Torque Converter Flex Lock-up Shudder

SUPERSESSION NOTICE

The information contained in this bulletin supersedes SB No. T-SB-0034-14.

- The Parts Information section has been updated.

Figure 1. Magnet Installation Locations

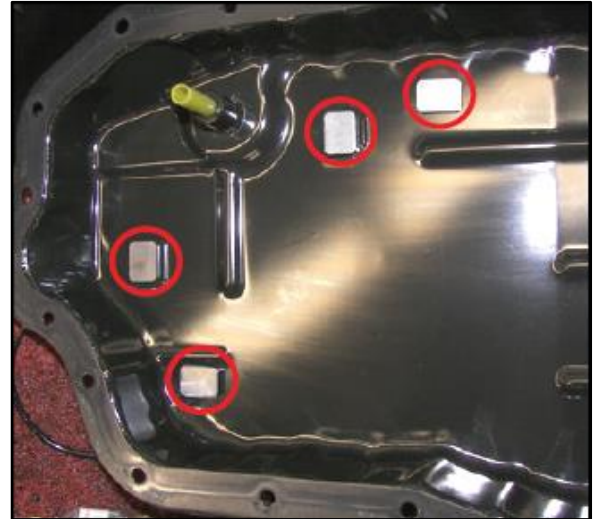
6. Install four NEW magnets in the locations shown.
